Project	IEEE 802.16 Broadband Wireless Access Working Group http://ieee802.org/16 >		
Title	Clarification of OFDMA Private Maps		
Date Submitted	2004-11-12		
Source(s)	Yuval Lomnitz, Hassan Yaghoobi	Intel Corp	yuval.lomnitz@intel.com, hassan.yaghoobi@intel.com
	Tal Kaitz, Ran Yaniv	Alvarion	tal.kaitz@alvarion.com, ran.yaniv@alvarion.com
	Dave Pechner, Doug Dahlby, Todd Chauvin	ArrayComm Inc.	dpechner@arraycomm.com, dahlby@arraycomm.com, chauvin@arraycomm.com
Re:	IEEE P802.16-REVd/D5		
Abstract	This contribution introduces clarifications for OFDMA private maps		
Purpose	Adopt into P802.16d/D5 corrigenda		
Notice	This document has been prepared to assist IEEE 802.16. It is offered as a basis for discussion and is not binding on the contributing individual(s) or organization(s). The material in this document is subject to change in form and content after further study. The contributor(s) reserve(s) the right to add, amend or withdraw material contained herein.

Clarify OFDMA AAS private maps Dave Pechner, Doug Dahlby

Figure 219—Illustration of OFDMA frame with multiple zones

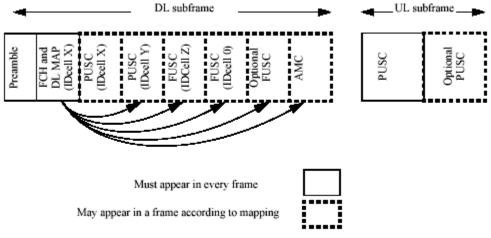
This eludes to the fact that the DL Map must be directly after the FCH and that there is only one DL MAP.

In addition, Figure 219 illustrates a single DL map pointing to all zones.

Again, alludes to the fact that there is a single DL map and it directly follows the FCH.

It is proposed to allow compressed maps to exist anywhere within an AAS Zone. When located in an AAS zone, the private map can be pointed to by a broadcast map, a DLFP message, or another private map in a previous frame. If the private map shares an allocation with other management messages or a data PDU, then the private map must be the first element in the allocation. Private maps are only allowed to use unicast CID values. Allocations pointed to by a private map must occur within the same AAS zone as the private map. Both UL and DL allocations are relative to the next frame.

The compressed map must occur directly after the DL Frame Prefix, or can be used as a private map in an AAS zone. When located in an AAS zone, the private map can be pointed to by a broadcast map, a DLFP message, or another private map in a previous frame. Other restrictions of private maps include:

- The private map must be the first message in a PHY burst
- Private maps are only allowed to use unicast CID values.
- Allocations pointed to by a private map must occur within the same AAS zone as the private map.
- Both UL and DL allocations included in the private map are relative to the next frame + frame offset value negotiated with the SS (see 11.8.3.7.6).
